**Staff Analysis of Proposed Amendment to the
Dane County Water Quality Plan,
Revising the Sewer Service Area Boundary and Environmental Corridors
in the Central Urban Service Area**

RE: Proposed Amendment to the Dane County Water Quality Plan, Revising the Sewer Service Area Boundary and Environmental Corridors in the **Central Urban Service Area**, McFarland, Dane County, Wisconsin.

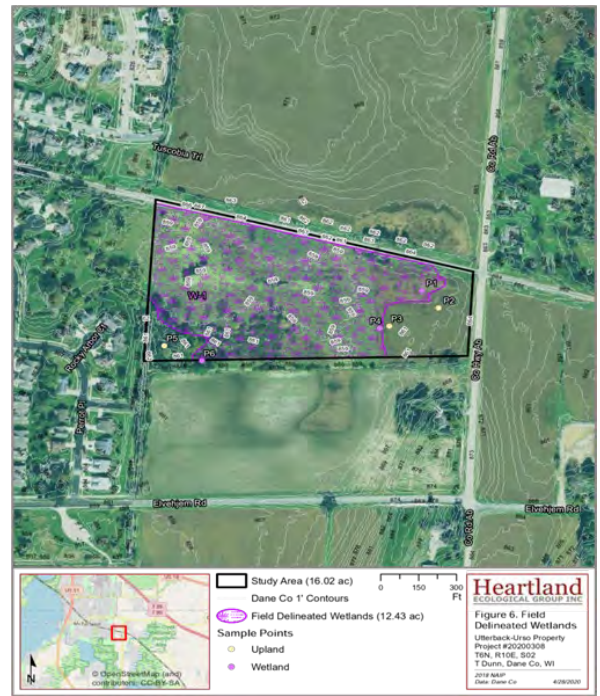
The wetland delineation on the Utterback-Urso property was also conducted in September 2019 by Heartland Ecological Group, Inc. The site investigation and field delineation determined there was one wetland covering approximately 12.4 acres over the majority of the property (see map at right). The wetland is best described as complex of wet meadow, shrub carr, and hardwood swamp that is potentially connected to Mud Lake. The dominant vegetation observed in the wetland was fall panic grass, reed canary grass, woolgrass (*Scirpus cyperinus*), honeysuckle (*Lonicera x bella*), common buckthorn, box elder (*Acer negundo*), and quaking aspen (*Populus tremuloides*). According to the 2008 *Dane County Wetlands Resource Management Guide*, this wetland was not inventoried. This wetland is proposed to be designated as environmental corridor with a 75' buffer.

6. Maintain the existing 100-foot buffer width for the wetland on the Utterback-Urso property.

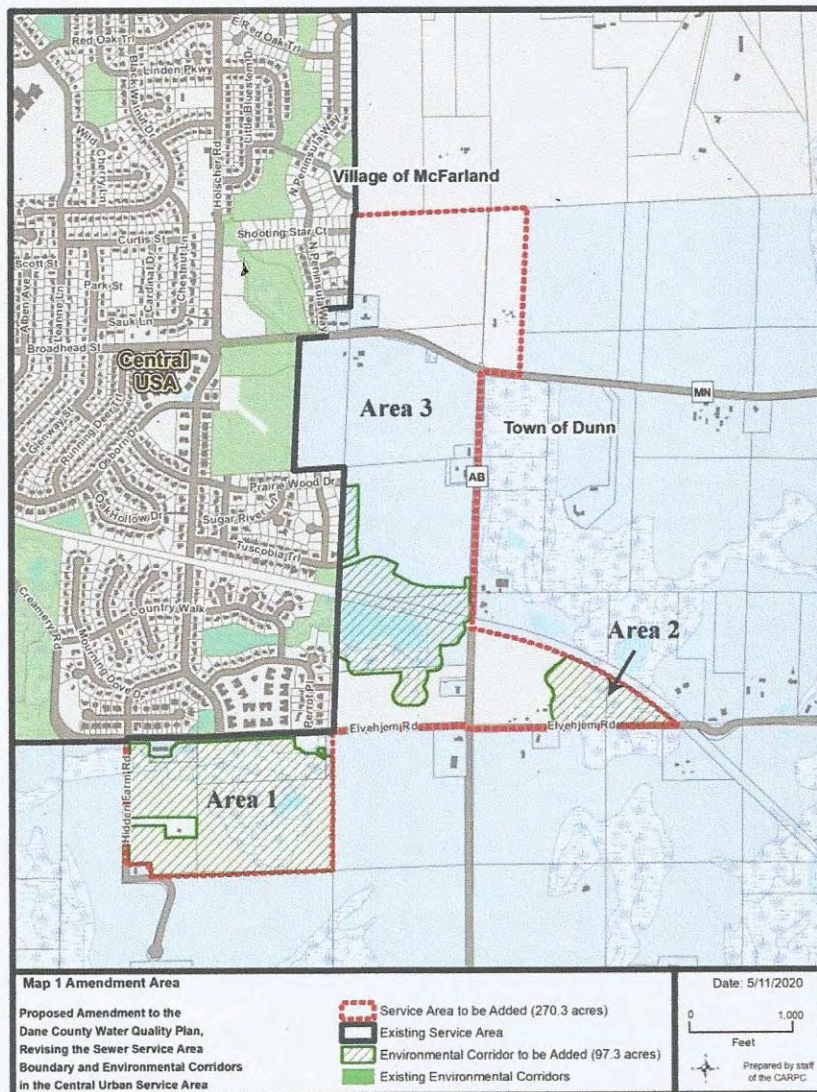
The Skare Mound Group (DA-90) is currently recorded along the southern edge of this area. Early reports about the site provide few details and the exact boundaries of the site are unknown. A single linear mound is known to be extant, but other undocumented mounds may be present. While all surface indications of the mounds may have been removed, subsurface features, including burials, may be present.

These developments should cease until the nature and extent of the cultural resources on this parcel can be determined.

The area should be surveyed by an archaeologist qualified to work within the boundaries of a human burial site. Two paper copies and one digital copy of the report must be submitted to our office.

No previously recorded sites have been reported for this area. However, the area has never been examined for the presence of archaeological resources. A review of available information indicates that wetlands and the head waters of Door Creek are present in the proposed amendment area. As a result, we recommend that an on-the-ground archaeological survey of the area south of MN Rd. be completed. Once the survey is completed, two paper copies of the report and one digital copy should be submitted to our office.

No previously recorded archaeological sites have been recorded in, or adjacent to the parcel delineated in the amendment. However, the area has never been examined for the presence of archaeological resources. A review of available information indicates that wetlands and the head waters of Door Creek

are present in the proposed amendment area. As a result, we recommend that an on-the-ground archaeological survey of the area be completed and that two paper copies of the report and one digital copy be submitted to our office.
